# **CONTAINMENT ASSESSMENT FOR AFAN SLUDGE TREATMENT CENTRE**

Revision	Date	Originator	Checker	Approver	Description
01	21/07/2023	Vishal Gavali	Bill O'Leary	Rosie Green	Containment assessment for STC
02	20/10/2023	Vishal Gavali/ Oscar van Paassen	Rachael Cross/ Anita Manns	Rob Evans	Containment assessment amendments for Afan STC based on NRW comments
03	04/10.2024	Vidhya M/Giri Sankar	Oscar van Paassen	Gavin Davies	Containment assessment amendments for Afan STC based on proposed modelling results

Document reference: B16399-123532-ZZ-XX-RP-WA-HY1008

Figure 9 - Groundwater Vulnerability Map

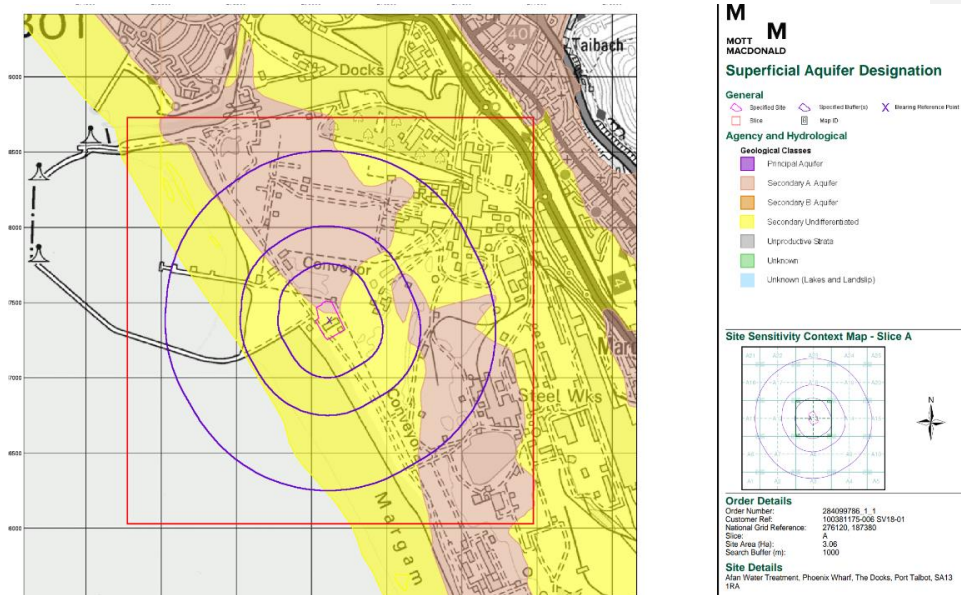
Commented [AM63]: Need to introduce the map below and provide a figure ref and source
